# UNITED STATES PATENT AND TRADEMARK OFFICE

APPLICATION NO.	FILING DATE	FIRST NAMED INVENTOR	ATTORNEY DOCKET NO.	CONFIRMATION NO.
10/667,115	09/19/2003	Russell Norman Mirov	SUN03-0112	8531

## Office Action Summary

### DETAILED ACTION

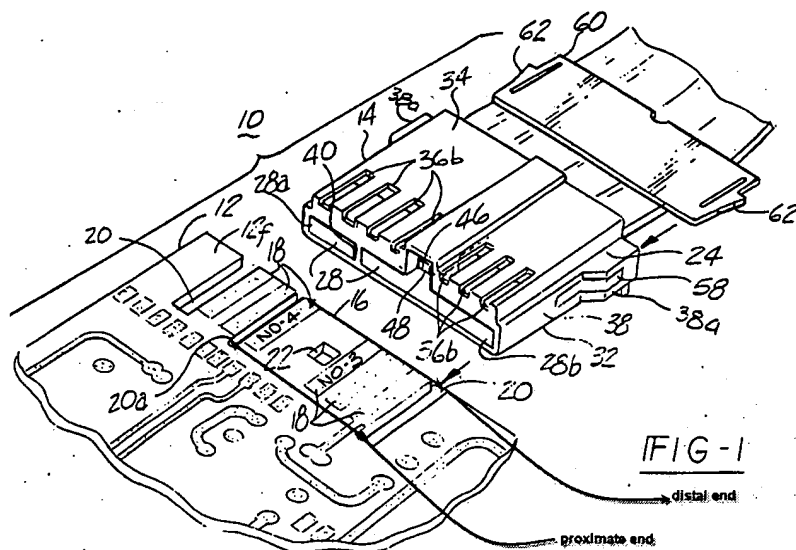
As to claims 1-3, Matson discloses a circuit board (12, column 2, line 7) as shown in figures 1-2 comprising: a mechanism (16, column 2, line 9) comprising:

signal means for (wire traces 18, and circuitries formed in/on the circuit board 12) conducting a signal between the mechanism (16) and the circuit board (12); and

separation means (gaps 20, column 2, line 15) for facilitating detachment of the mechanism (16) from the circuit board (12);

identification means for (labels No.1-No.6, figure 1 shows the label No.3 and No.4) identifying the mechanism (16);

wherein the circuit board becomes at least partly non-functional if the mechanism is detached from the circuit board.

As to claims 5-7, Matson discloses in figure 1 the identification means being a circuit (conductor run (18), visible identification code (labels No. 3, No. 4), and being protected (by a molded connector 14) from being easily manipulated.

As best understood to claims 34, 40-41, Matson discloses a circuit board assembly, shown in figure 1 comprising: a circuit board (12) comprising a tab (key tab-16) having: proximate and distal ends (see figure above); and two opposing sides separated from the assembly by gaps (slots 20); an identification (labels N0.1-No.6 formed on conductor runs 18 to identify the function of leads/pins of the conductor runs) situated on the tab (16); and a signal conductor (traces or wirings on the board) extending from the circuit board to the tab and configured to convey a signal when the assembly is powered, and wherein removal of the key from the circuit board assembly causes said portion of the signal conductor to be not electrical contact to the assembly.
